THIRD READING SUMMARY SHEET

ZONING CASE NUMBER: C814-88-0001.10 – Canyons @ Rob Roy Rezoning

ZONING CHANGE REVIEW SHEET

Staff recommends Planned Unit Development (PUD) zoning with the following changes to Exhibit "H" of the PUD Land Use Plan –

REDUCTION OF SHEET 1

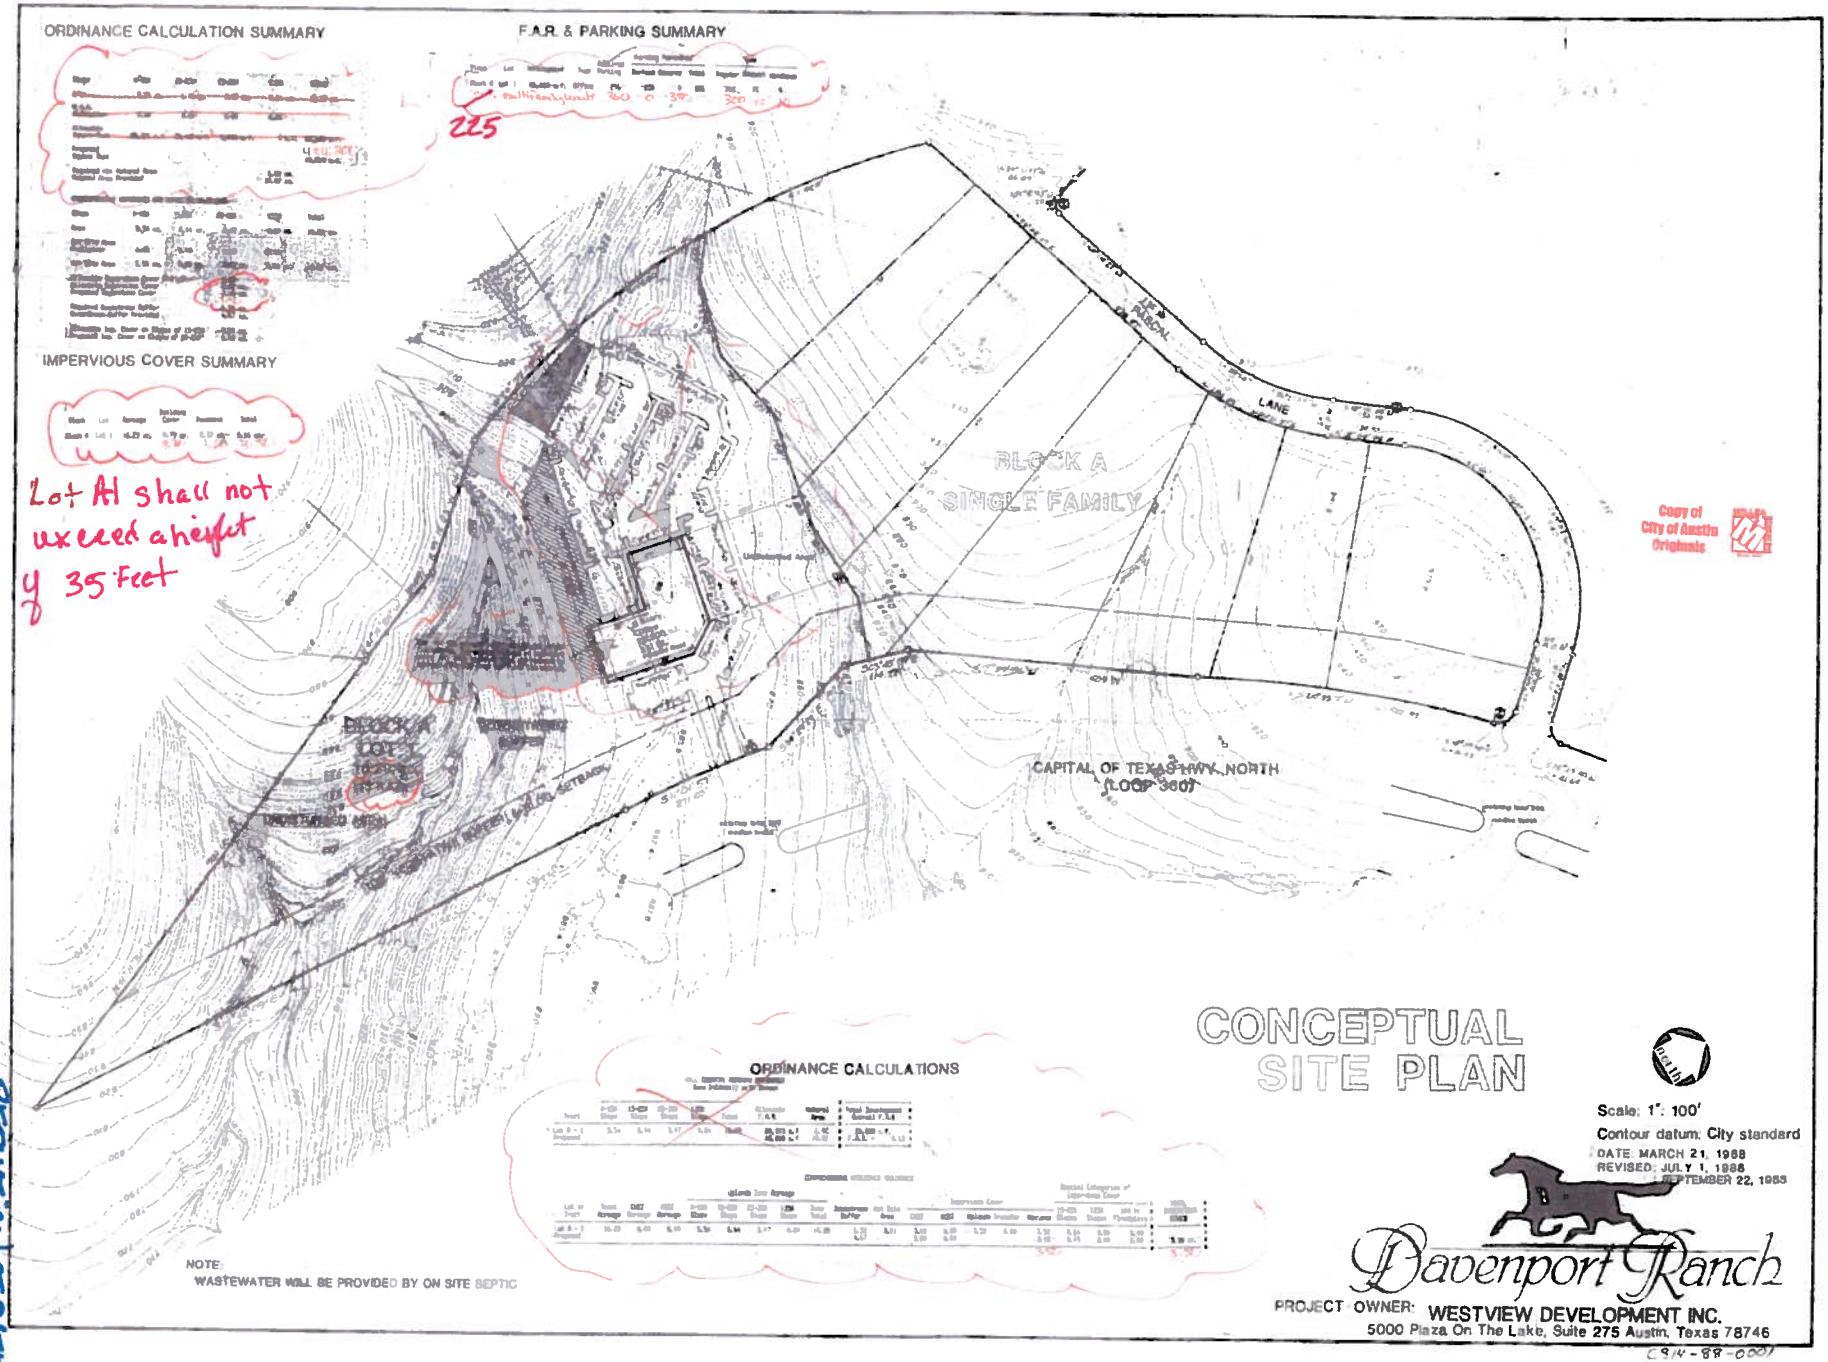
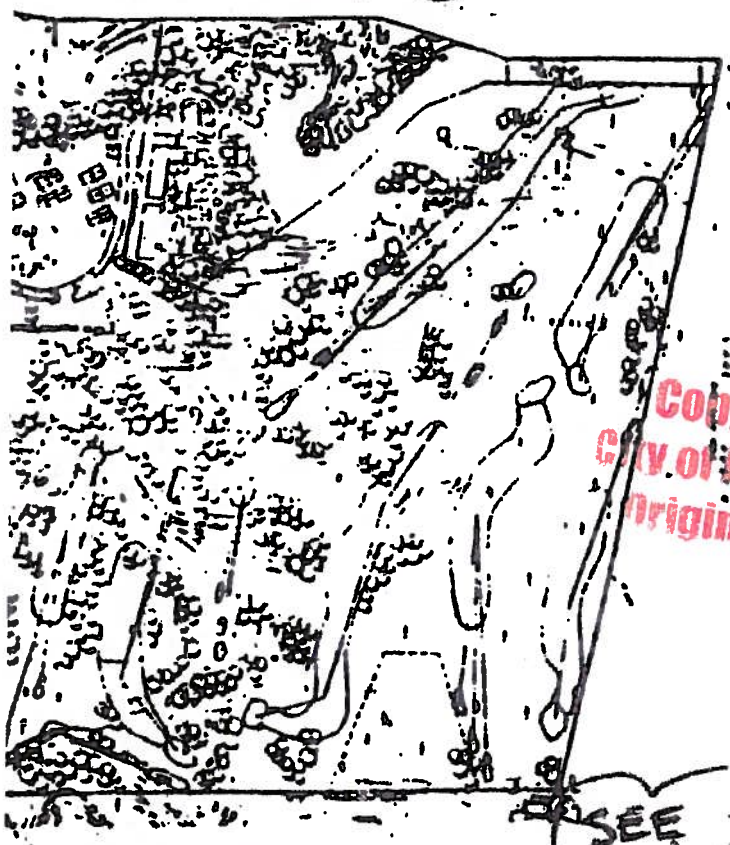
1. Change the Overall Summary by General Land Use Table on Sheet 1 to reflect a change from office use to multifamily use; adjust the acreages accordingly.

2. Change the Land Use Summary Table on Sheet 1 to reflect the correct lot and change the proposed land use from office to multifamily.

Exhibit "H" Land Use Plan. Change the Overall Summary by General Land Use Table on Sheet 1 to reflect a change from office use to multifamily use; adjust the acreages accordingly.

Exhibit "H" Land Use Plan. Change the Land Use Summary Table on Sheet 1 to reflect the correct lot and change the proposed land use from office to multifamily.

Justification: The Property was zoned for office use in 1988, since then it has remained undeveloped. West Austin lacks a sufficient supply of multifamily development for families looking to move to the area that otherwise might not be able to afford owning their own home. The few multifamily developments located in the surrounding area experience an occupancy rate of over 90%. Additionally, the proposed low density multifamily residential use provides a better transition between Capital Texas Highway located to the west and the residential uses located to the north and east of the site.

REDUCTION OF SHEET 2

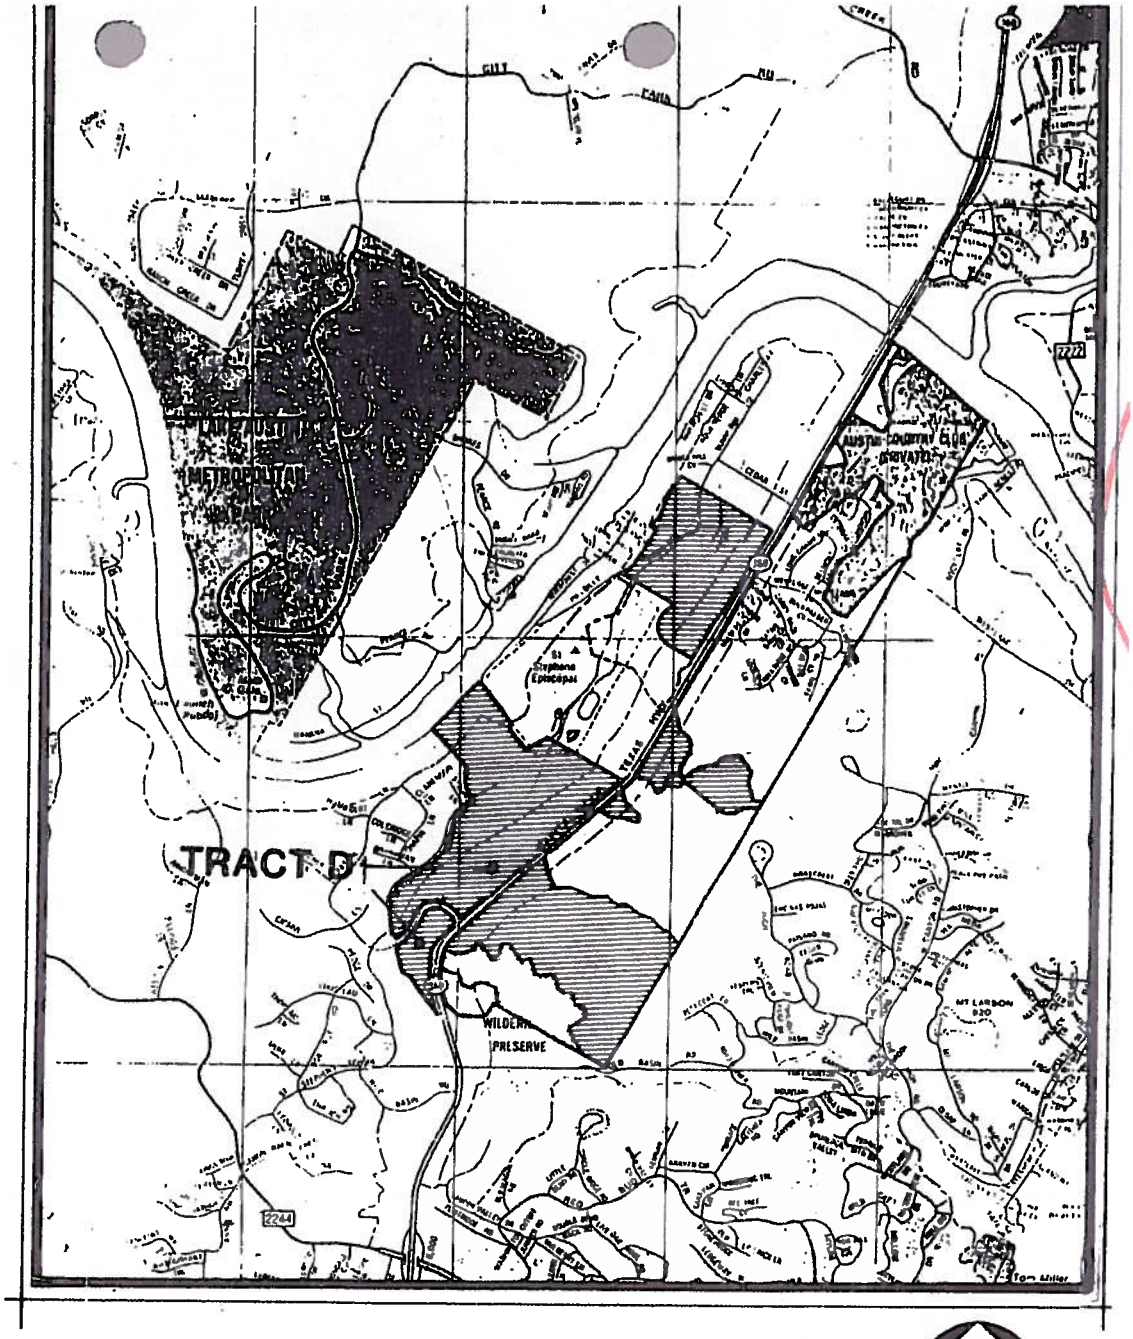
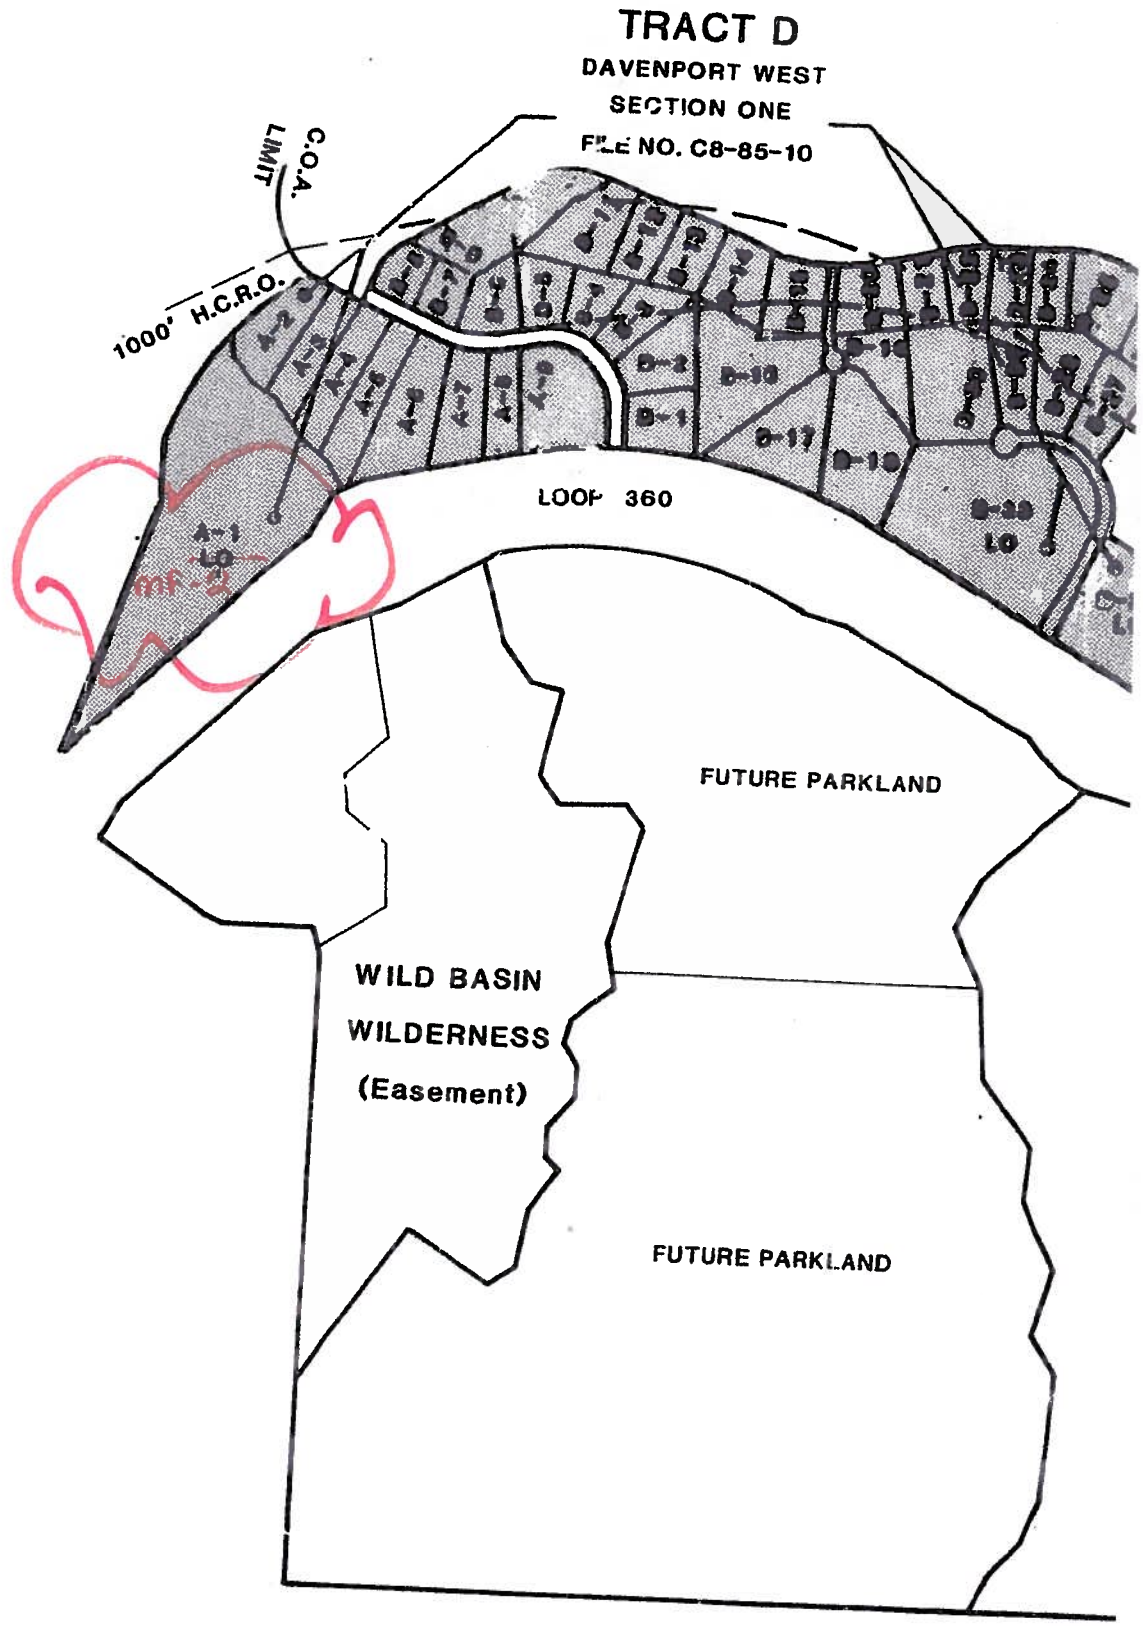
3. Clarify Ordinance Compliance Note #1 on Sheet 2 to read "*Single family* residential areas are limited to a density of one unit per two acres of gross site area, with minimum one acre lots."

4. Change the Hill County Roadway Ordinance Calculations on Sheet 2 to deduct the site area calculations of Lot A-1.

5. Change the F.A.R & Parking Summary Table on Sheet 2 to reflect Lot A-1 as a multifamily project.

6. Change the diagram on Sheet 2 for Lot A-1 from "LO" to "MF-2".

Exhibit "H" Land Use Plan. Clarify Ordinance Compliance Note #1 on Sheet 2 to read "*Single family*" residential areas are limited to a density of one unit per two acres of gross site area, with minimum one acre lots."

Exhibit "H" Land Use Plan. Change the Hill County Roadway Ordinance Calculations on Sheet 2 to deduct the site area calculations of Lot A-1.

Exhibit "H" Land Use Plan. Change the F.A.R & Parking Summary Table on Sheet 2 to reflect Lot A-1 as a multifamily project.

Exhibit "H" Land Use Plan. Change the diagram on Sheet 2 for Lot A-1 from "LO" to "MF-2".

Justification: As supported by Section 1.04 of the Restrictive Covenant recorded in Volume 10909, Pages 1601-1616 of the Real Property Records of Travis County, Texas for the Davenport Ranch West Planned Unit Development Section One, this restriction was intended to apply solely to single family residential development. A copy of the Restrictive Covenant is attached with the companion Restrictive Covenant Amendment case.

Justification: Per the Hill County Roadway Ordinance the floor-to-area limitations only apply to nonresidential buildings.

Justification: The parking table only provides parking calculations associated with the office development on Tract D. Since the use is changing from office to multifamily, the table has been updated accordingly.
